NRC APR 1400 Fuel Rack Meeting Action Items - March 9, 2017

Please refer to the following figures for run #17 and #36.

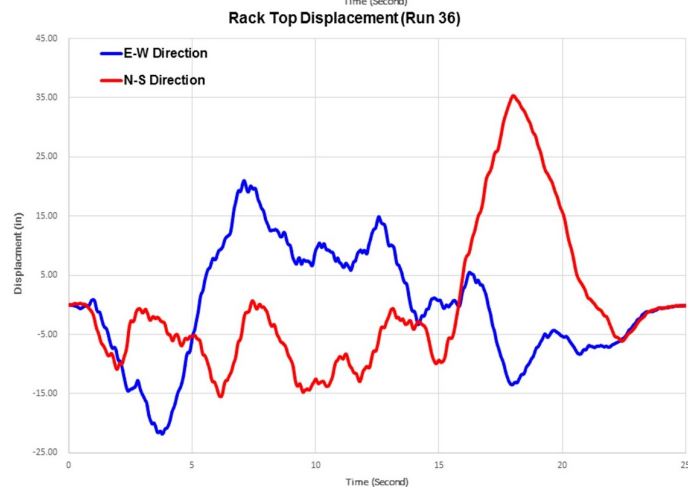
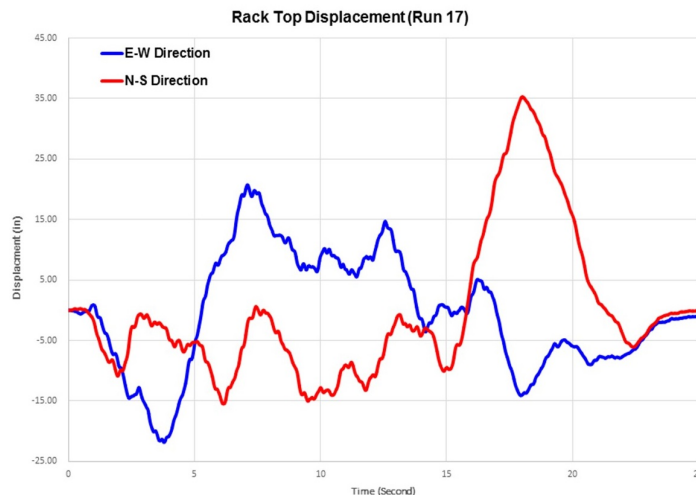
Item 5 - Provide displacement plots of one of the racks to compare results between time steps for the time step sensitivity

- a. Revise discussion of time step convergence in 3.7.4.6.

KHNP/Doosan agrees to include the above figures in Revision 3 of the report.

Subsection 3.7.4.6 of TeR (APR1400-H-N-NR-14012-P) will be revised as follows:

Comparison of a run at one half the fixed time step used for all other runs showed small changes in calculated results comparable to the run to run variation with the different time histories. Small differences, as opposed to identical results, are expected because the time step used affects where in each time history the acceleration is taken and how long it is applied. The 5% convergence value for dynamic simulation is applied to calculate the force and displacement quantities of interest.

Figure 1-1. Boundary Condition and Applied Load of FE Model

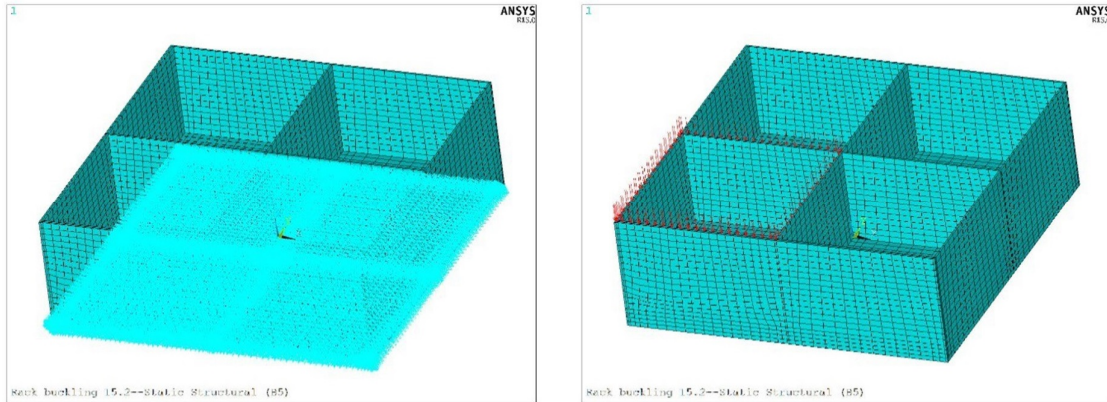
Item 9 - Explain calculations and trace origins of values used for lowest margin results:

- a. Cell wall buckling

A compressive force for cell wall buckling evaluation is calculated as follows:

$$\sigma_{\text{comp}} = 1.2 \times 21400 \times \text{FACT2} = 71.0 \text{ MPa (10,298 psi)}$$

The above calculation is based on the maximum stress factor for the net vertical force on the gross cell cross-section. The vertical forces on the rack support pedestal reflect the weight of the rack plus the stored fuel assemblies during the seismic event. Since the stored fuel assemblies are supported by the rack baseplate, the actual compressive load on the rack cell structure is significantly less than the value determined by the results of dynamic simulations. It is appropriate to use a FACT2 value for cell wall buckling evaluation.

The critical elastic buckling load of cell wall is calculated by ANSYS eigenvalue analysis. Two by two cells of spent fuel storage rack are considered in the buckling analysis. The FE model reflects a reinforcement plate that is welded to outer side of the cells. The boundary condition and applied unit load (1 MPa) of FE mode is shown in Figure 1-1. A fixed boundary condition is applied on bottom surface of the FE model. Figure 1-2 depicts the results of buckling analysis.

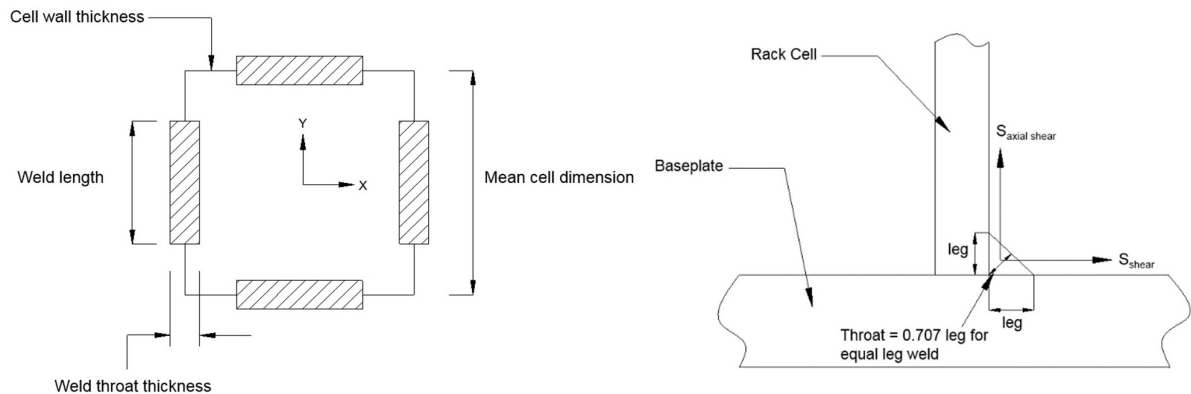
b. Base metal shear

Rack cell-to-baseplate is fillet weld with equal legs. Shear stress in a fillet weld is evaluated at the throat area that is a minimum area at the fillet weld. The throat thickness of a fillet weld having equal legs is obtained by multiplying the size of the leg by 0.707 as shown in the following figure.

The conversion factor (ratio) values are developed from consideration of the differences in material thickness and length versus weld throat dimension and length, as follows:

$$\text{Ratio} = [(220 + 2.5) \times 2.5] / (180 \times 2.5 \times 0.707) = 1.75 \text{ (for the SF SRs)}$$
